ADDENDUM NO. 01

Project: **2024 Jersey Village High School Renovation**
Cypress-Fairbanks Independent School District

Issued by: Texas Arcadis Inc.
P.O. Box 891209
Houston, Texas 77289
281-286-6605

Texas Arcadis Inc.
Project No.: 202319

A2.24
 AREA 'J2' 2ND FLOOR PLAN

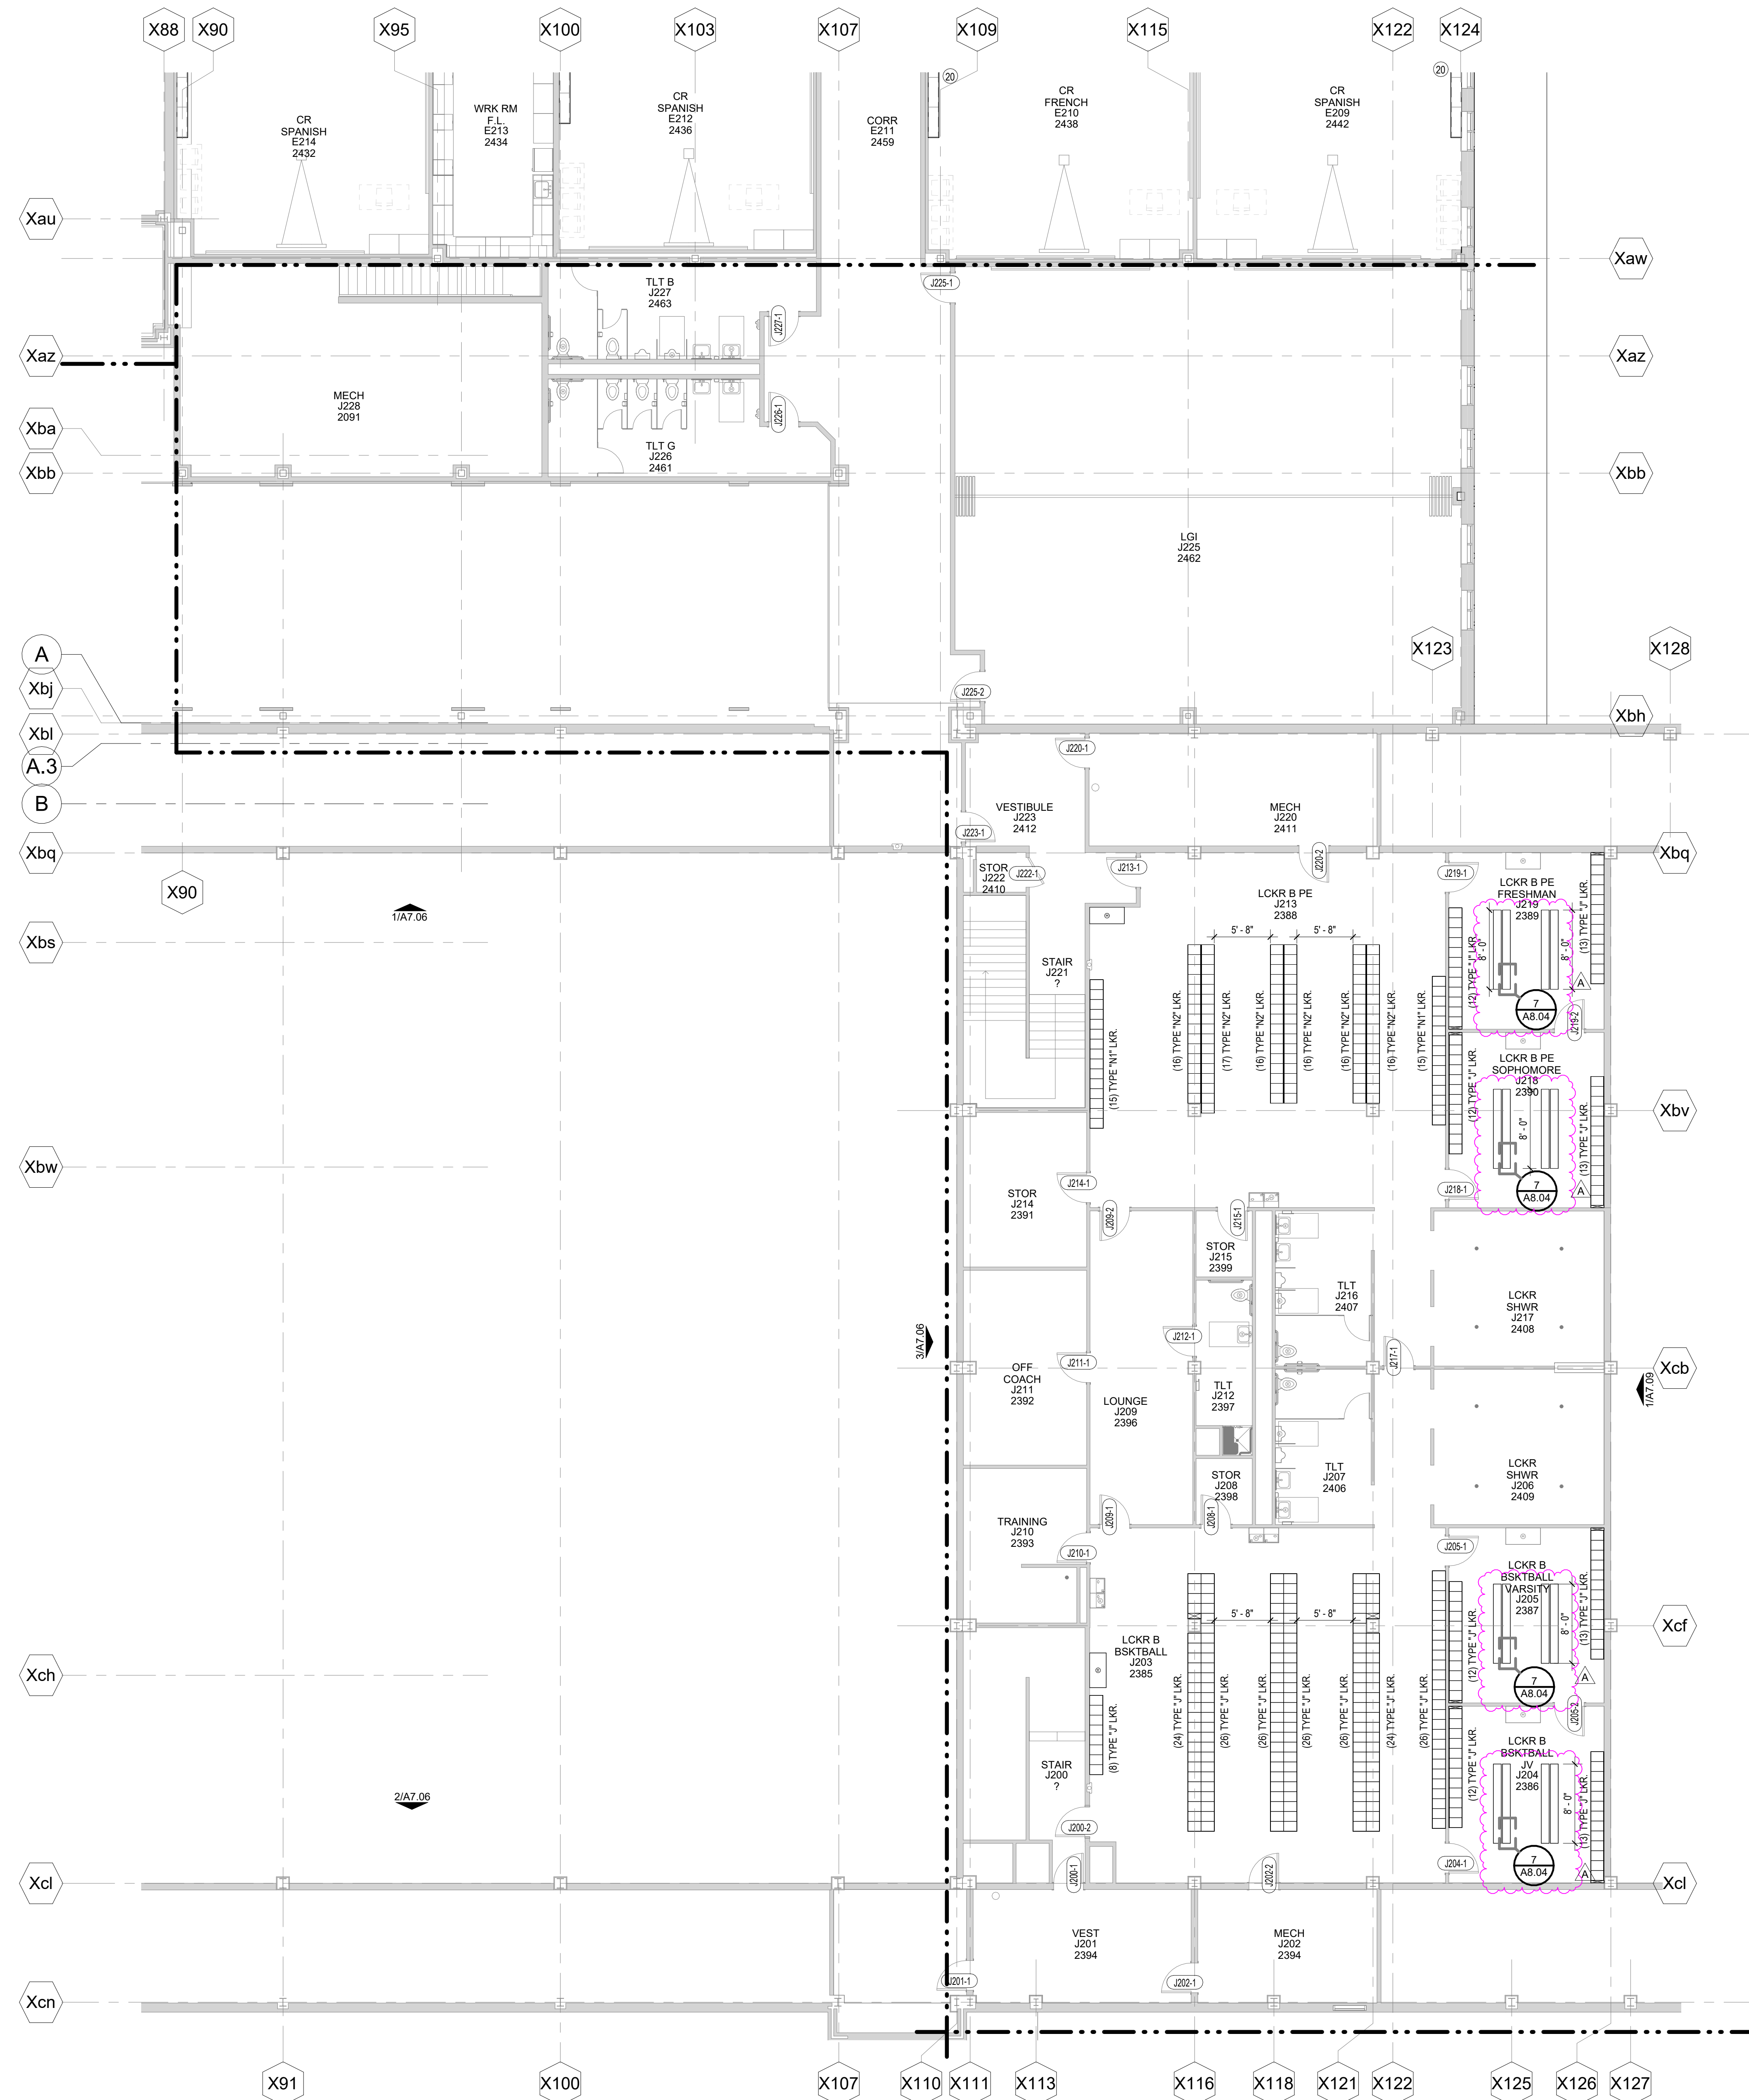
- 61. Sheet A2.24 - Area “J2” 2nd Floor Finish Plan
 - a. Install new benches per reissued sheet, reference detail 7/A8.04.
 - b. Add dimensions to new locker room benches.
- 61. Sheet A4.03 – Roof Details
 - a. Revise roof opening details per reissued sheet.
- 62. Sheet A4.04 – Roof Details
 - a. Revise roof opening details per reissued sheet.
- 63. Sheet A8.00 – Casework Sections.
 - a. Revise casework sections per reissued sheet.
- 64. Sheet A8.01 – Casework elevations and details.
 - a. Revise casework elevations and details per reissued sheet.
- 65. Sheet A8.02 – Casework elevations and details
 - a. Revise casework elevations and details per reissued sheet.
- 66. Sheet A8.03 – Casework elevations and details
 - a. Revise casework elevations and details per reissued sheet.
